2015SYE149 – 128-136 Willarong Road, Caringbah

DA15/1278

ASSESSMENT REPORT APPENDICES

Appendix	A	Draft Conditions of Consent
	B	Pre-Application Discussion dated 9 June 2015
	C	Architectural Review Advisory Panel Report dated 19 November 2015
	D	NSW Police Comments dated 22 December 2015
	E	Clause 4.6 Objection to Building Height

Figure 1: Height non-compliance in section of Building 2

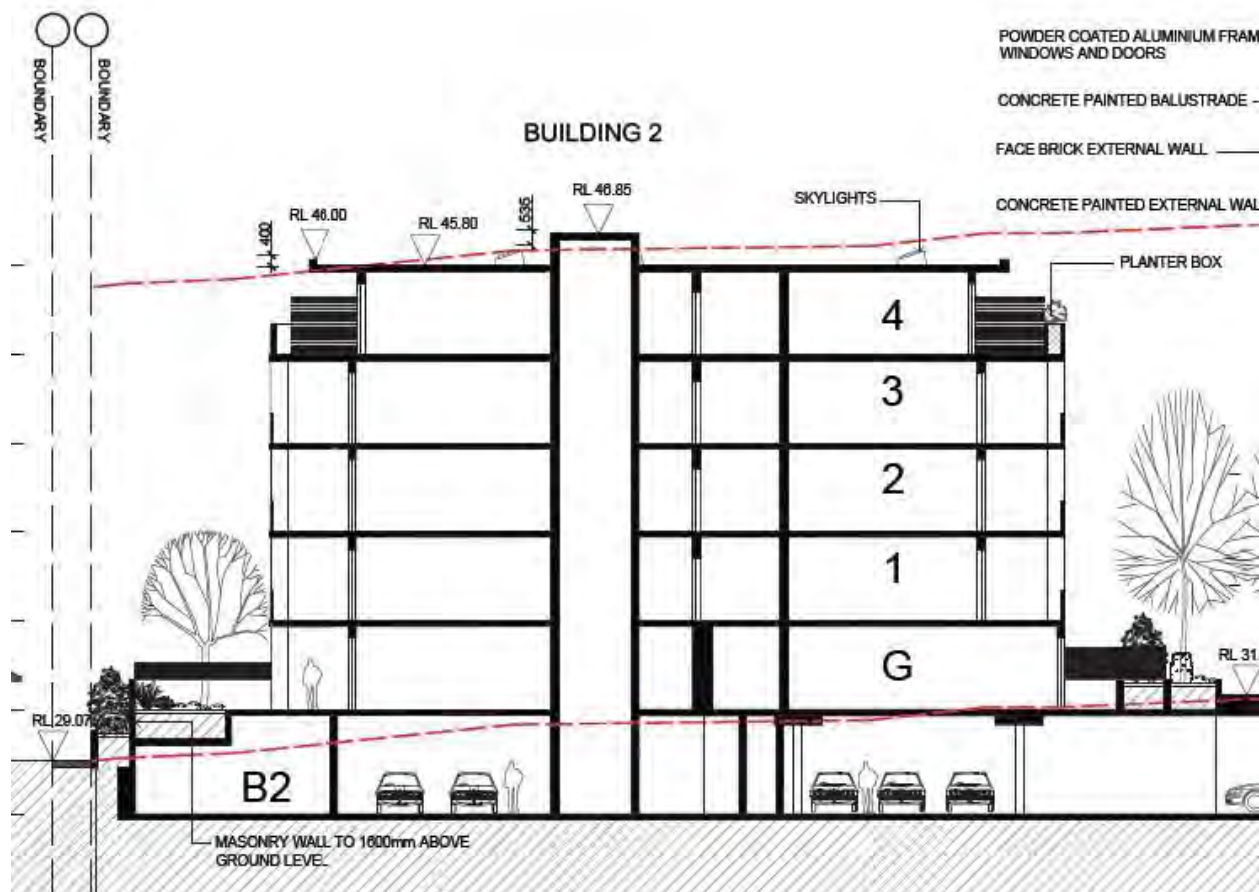
As indicated in the extract of the section at Figure 1 and the eastern elevation at Figure 2, Building 2 has a minor breach in relation to the roof and fifth floor wall within the north eastern section of the building, as the site naturally slopes to the north east towards Willarong Road. In addition, the north eastern corner of Building 1 and north western corner of Building 2 exceeds the 16m height limit by approximately 100mm. At the greatest extent (Figure 2) the height breach is 0.93m (5.8%) within a small portion of the building indicated at Figures 1 and 2.

The plans propose a height difference of around 1m between the ground floors of each building to take account of the fall in the land towards the north eastern corner of the site. As a result, a small sections of each building exceed the height limit.
